ADDENDUM # 2
UC Merced Medical Education Building Project
Environmental Impact Report
State Clearinghouse Number 2021040047

Changes to the UC Merced Medical Education Building Project

October 2023

FIGURE 3-2

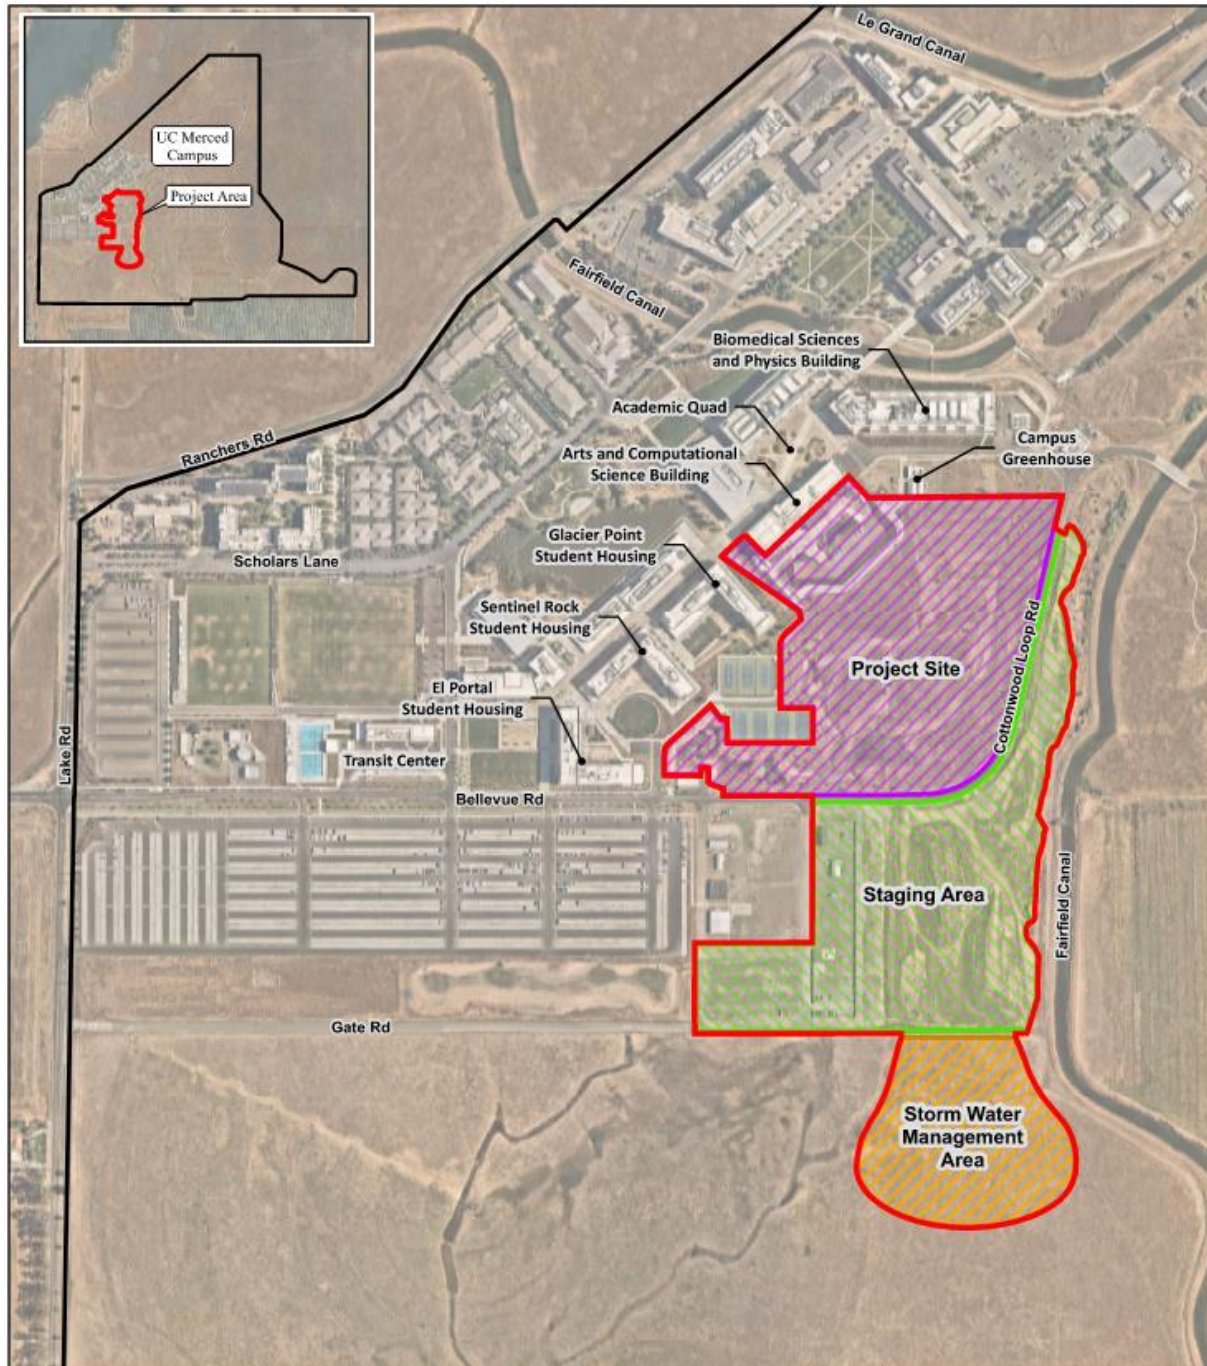
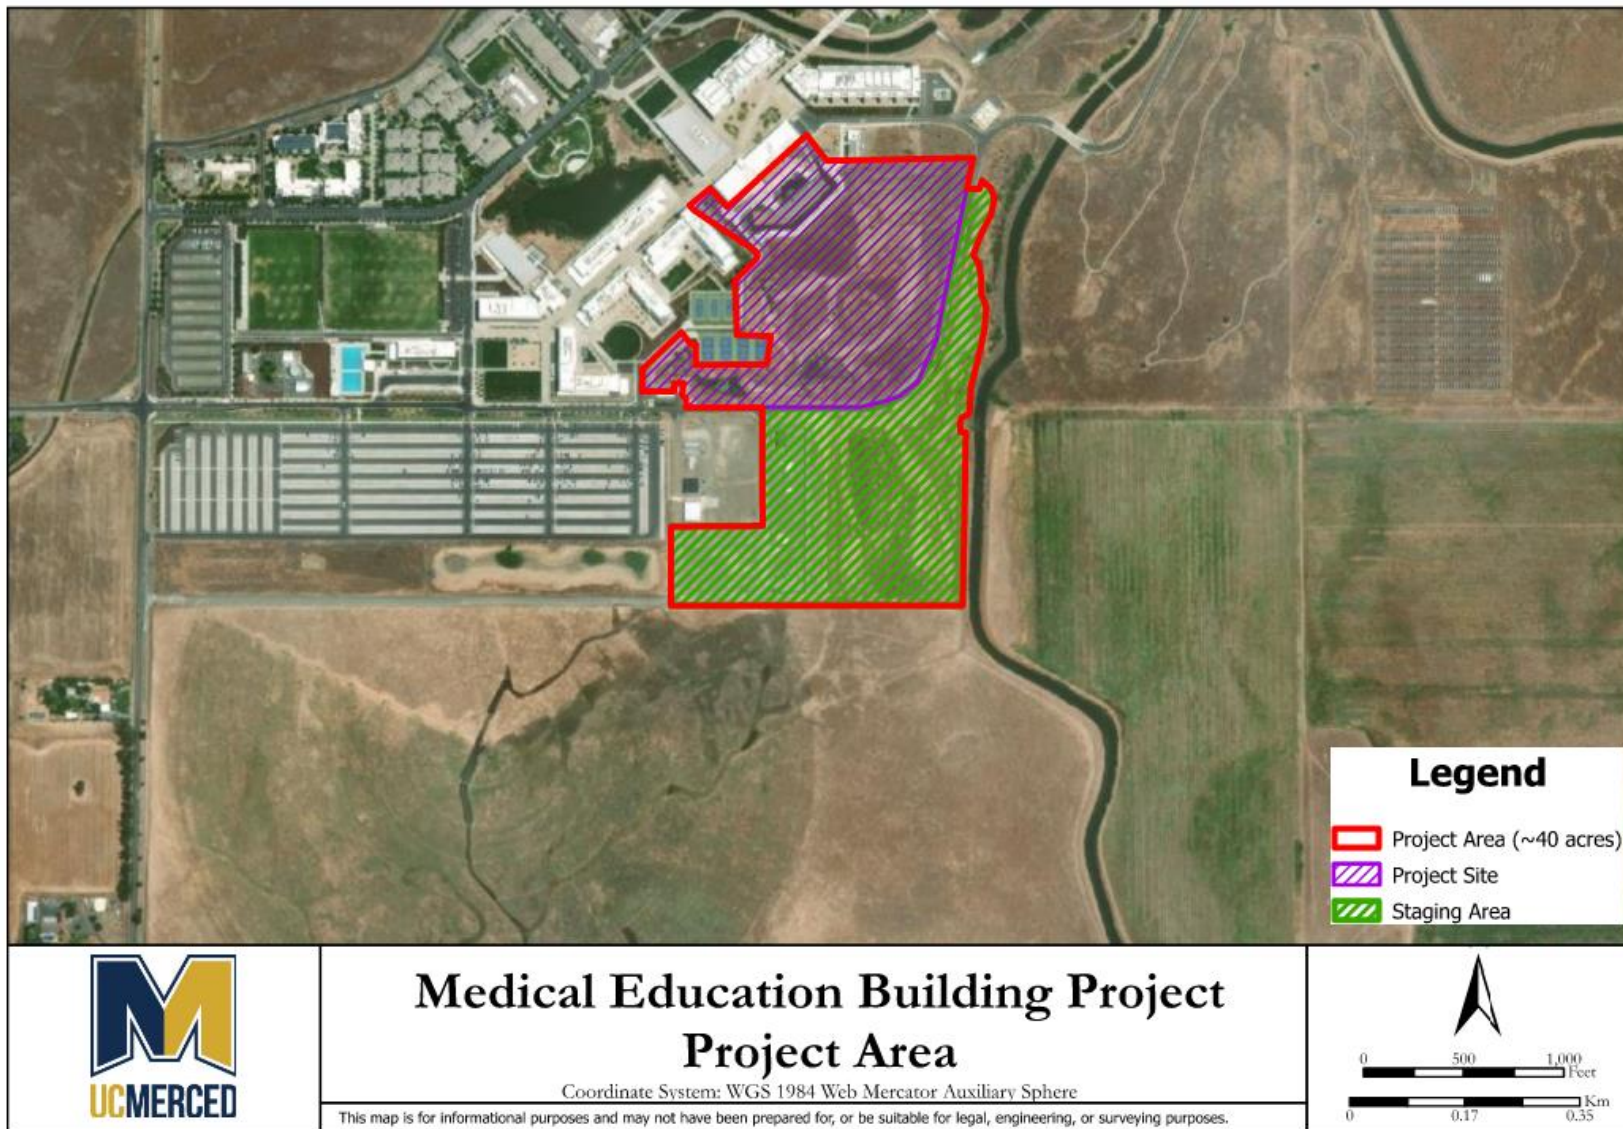
In conjunction with the revised building design, the site plan has been revised to reduce landscaping and tighten up the building site. As a result of these minor changes to the site plan, the total amount of impervious surfaces would be reduced from 4.4 acres to 3.7 acres, which includes the building footprint and hardscape areas. The previously analyzed 46.5-acre Project Area, comprising the building site, the area that would be used for construction staging, and the area where the proposed storm water detention basin would be located, will be reduced due to the elimination of the new 8-acre stormwater basin and modification of the existing stormwater basins within the project site to accommodate stormwater.

The revised stormwater basin plan would reduce the amount of disturbed area by approximately 8 acres. The EIR analyzed filling in and grading the stormwater basins located within Cottonwood Meadow and excavating a new stormwater basin. The project will now re-grade those areas within Cottonwood Meadow to accommodate the increased stormwater flows and the reduced stormwater containment created by the Medical Education building project. As a result, the current views of the area will remain similar to what exists today, and thus would not adversely affect public views of the campus from Lake Road.
